Model: Bellini		Date: 25-Apr-03	No.: RA294061
Subject: Service Parts of Punch Heads		Prepared by: S. Orita	
From: 2nd Tech Support Sec. Service Support Dept.			
Classification:	<input checked="" type="checkbox"/> Troubleshooting <input type="checkbox"/> Mechanical <input type="checkbox"/> Paper path <input type="checkbox"/> Other ()	<input type="checkbox"/> Part information <input type="checkbox"/> Electrical <input type="checkbox"/> Transmit/receive	<input type="checkbox"/> Action required <input type="checkbox"/> Service manual revision <input type="checkbox"/> Retrofit information

Model: B-C1 Punch Unit	Date:17-Aug-09	No.: RA812001
------------------------	----------------	---------------

Subject: Punch Unit		Prepared by: T.Toriumi	
From: 2nd Tech. Support Sec. Service Support Dept.			
Classification:	<input type="checkbox"/> Troubleshooting <input type="checkbox"/> Mechanical <input type="checkbox"/> Paper path <input type="checkbox"/> Other ()	<input checked="" type="checkbox"/> Part information <input type="checkbox"/> Electrical <input type="checkbox"/> Transmit/receive	<input type="checkbox"/> Action required <input type="checkbox"/> Service manual revision <input type="c

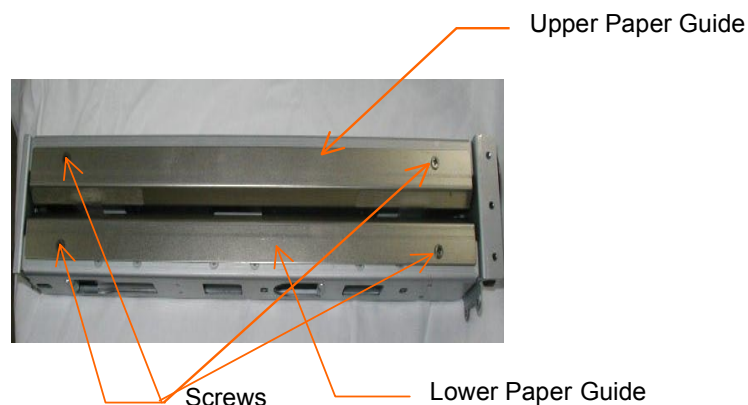
The following punch heads have been registered as service parts for replacement in the field, so that the entire punch unit does not have to be replaced when the punch heads fail:

P/N A8129501 (Punch Head – 8 mm) --- North America Version

P/N A8129502 (Punch Head - 6.5mm) --- European Version

1. To ensure a smoother punch head/receiver operation, the service part punch head is smaller than that fitted in new production machines. This creates a better match between the two, as both experience gradual wear during the course of operation.

Visual distinction: Service part punch head is gold (Production head is silver.)

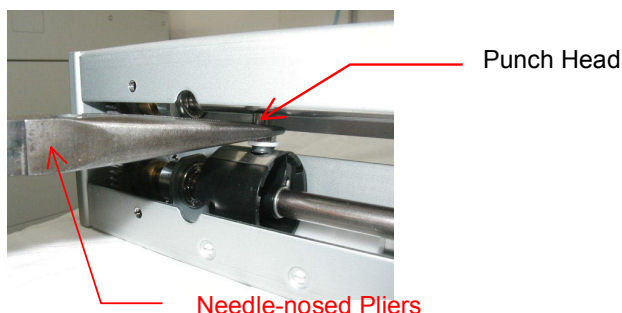
1. Remove the upper and lower guides (4 screws).

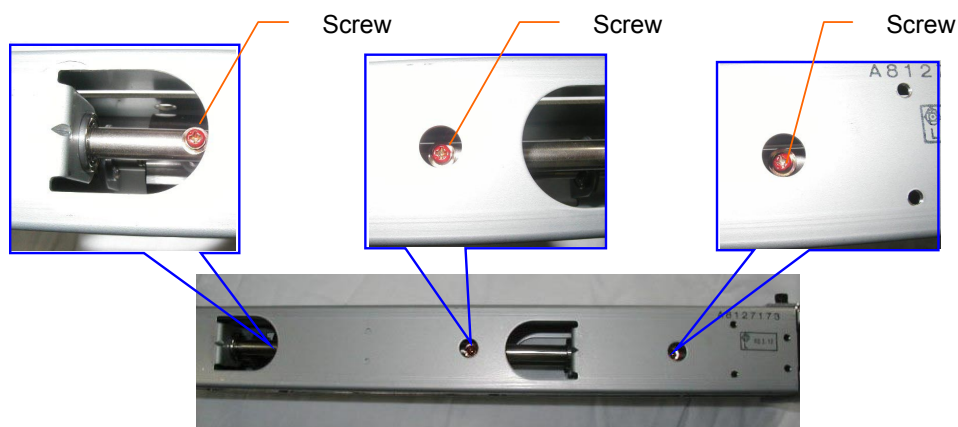
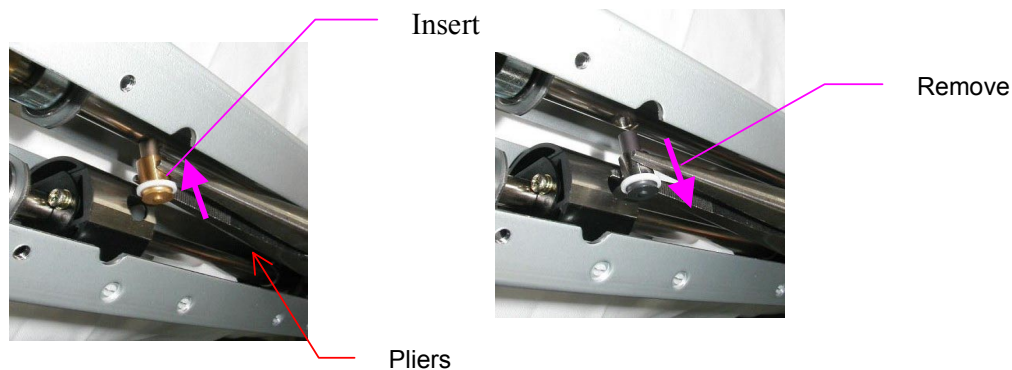
2. Rotate the drive gear until the punch head and punch head receiver are aligned.
3. Remove the punch head, holding the head with a pair of needle-nosed pliers (1 screw per head).

NOTE: a. Do not touch the punch head with bare hands.
b. Do not remove any other screws.

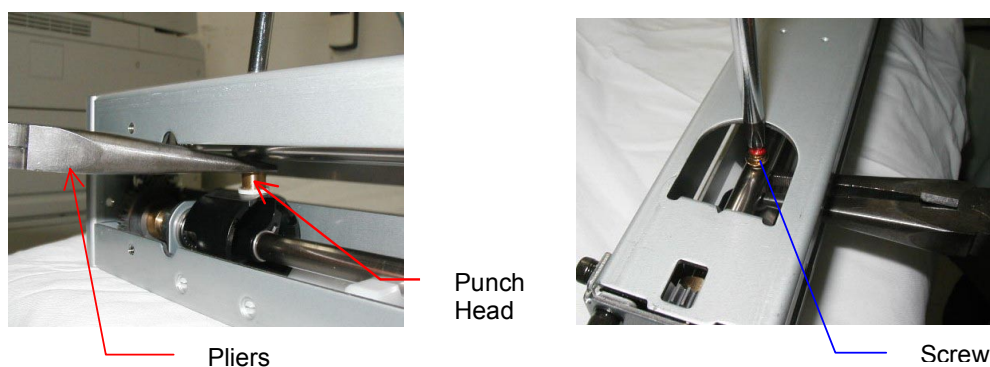
4. Insert the new punch head.

5. Secure the new punch head in place, holding it with a pair of needle-nosed pliers (1 screw).

NOTE: a. Do not touch the punch head with bare hands.
b. Make sure to attach the head perpendicular (90 degrees) to the shaft.
c. Do not remove any other screws.

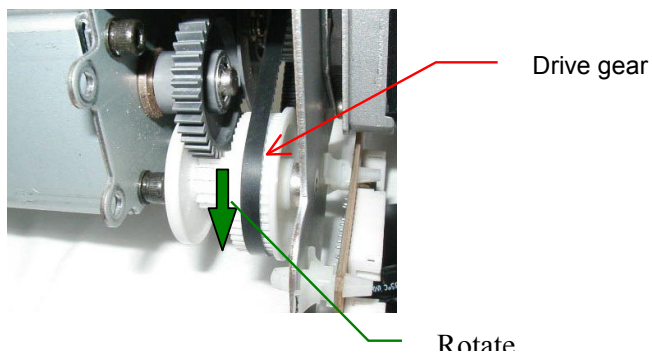
6. Reinstall the paper guides (4 screws).
7. Rotate the drive gear manually and confirm that the punch head/receiver mechanism functions smoothly (that the two are properly aligned with one another).

Note: Do not forcibly rotate the gear. If it is difficult to rotate, replace the entire punch unit.
